Subject: Amendment to Certificate of Compliance Application,  
Docket No. 71-9153

Teledyne Energy Systems herewith submits an amendment to our license application, TES-3147, "Sentinel 1S Radiation, Structural and Thermal Evaluation." The enclosed ten packages of seven pages each, replace pages 2-22 through 2-24 of Section 2.7.1 "Free Drop," submitted previously.

SUBJECT: DISTRIBUTION OF CHANGE - PAGES 2-22 thru 2-24.d

TES-3147

FIGURE 2.7-4  
SENTINEL IS SHIELD GEOMETRY

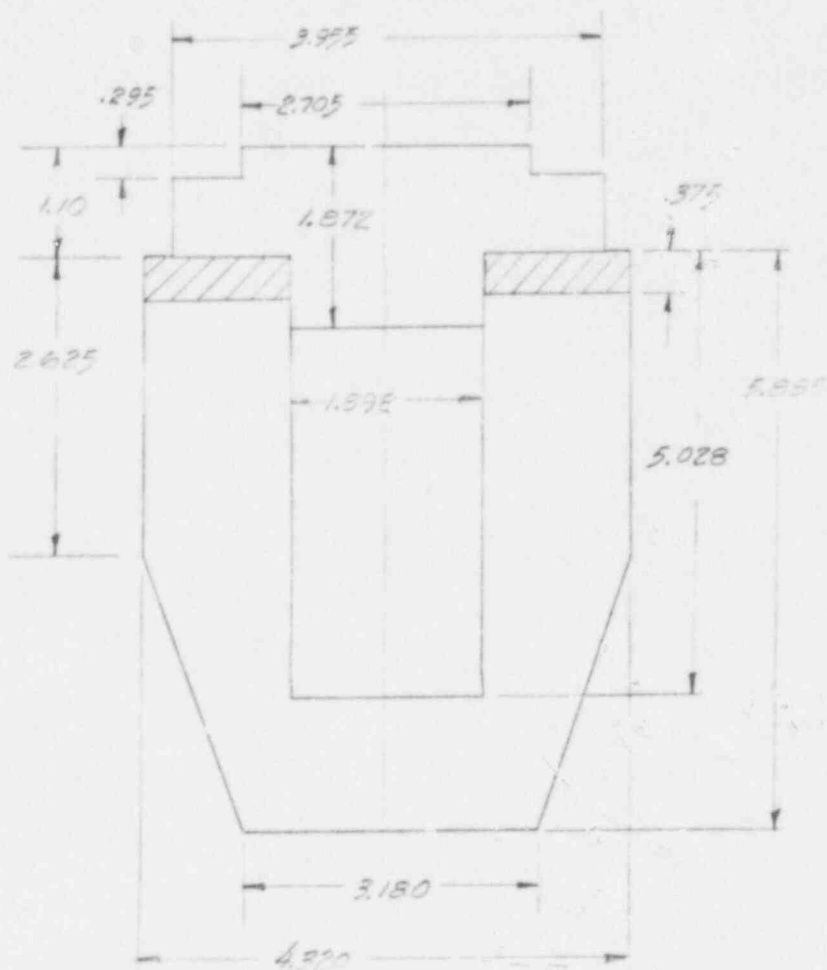
The radiation shield, fabricated from uranium - 3/4% titanium, is evaluated for direct impact response for two attitudes, side-on and top end-on. For both orientations energy is absorbed in bending of the cooling fins that are integral with the housing that surrounds the shield. It can be shown that the energy absorbed in bending is approximately 4000 in-lbs in each direction. However, this magnitude is insufficient since the available energy associated with a 50 lb shield and fuel capsule dropping 30 feet is,

For the end-on (top) impact the maximum stresses can be easily derived.

At the upper surface of the lid, the inertia force is,

$$P = 1366 (2.85 + 36.98 + 1.29 + 9.25)$$

$$= 68,805 \text{ lbs}$$

$$A = \frac{\pi}{4} (2.705)^2 = 5.747 \text{ in}^2$$

$$\therefore \sigma = \frac{68805}{5.747} = 11,972 \text{ psi}$$

The stainless steel ring has a minimum yield strength of 30,000 psi. The minimum area is,

$$A = \frac{\pi}{4} [(3.955)^2 - (1.898)^2] = 9.456 \text{ in}^2$$

The inertia force is  $1366 (36.98 + 1.29) = 52277 \text{ lbs}$ . Therefore, the stress is,

$$\sigma = \frac{52277}{9.456} = 5528 \text{ psi}$$

FIGURE 2.7-5  
FINITE ELEMENT MODEL  
- CENTRAL SECTION OF SHIELD

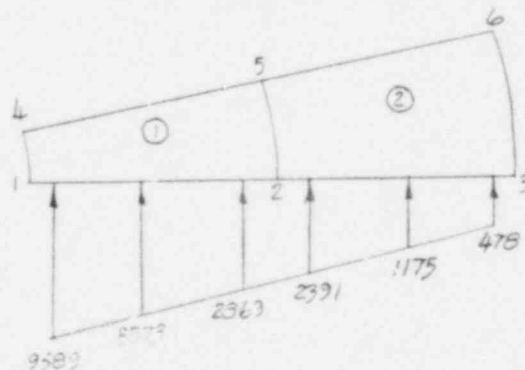
The inertia forces in the shield body are approximated by examining a section of unit length. The ANSYS finite element program was utilized where the thick walled circular section was modeled by 72 elements as shown in Figure 2.7-5. Each element is an isoparametric solid defined by four nodal points having two degrees of freedom at each node point, translations in the x and y directions. The tractions are based upon 1366 g's acting on the mass of each element in the -y direction. The total force is reacted as a line load at node 84. The resulting stresses are conservative since the constraints provided by the lid and lower end closure are neglected. The material properties of interest for the U-3/4% Ti include  $E = 26.0 \times 10^6 \text{ psi}$ ,  $\nu = 0.3$  and  $\rho = .672 \text{ lbs/in}^3$ .

The stress distributions of interest are located at  $\Theta = 0, 90$  and  $270^\circ$ .

- a. At  $0^\circ$  (elements 1 and 2) the stress distribution across the wall is the superposition of bending and compression as shown below.

- b. The maximum tensile stress occurs at  $R = .949$  inch and  $\Theta = 90^\circ$ . The value is 6979 psi.
- c. The maximum stress occurs at the line of contact with the impacting surface (node 84) of element 54. At this location there is a compressive stress (-13,091 psi) due to bending, a compressive stress in the y-direction (-19,735 psi) and a shear component. The resulting equivalent stress is 26,831 psi.
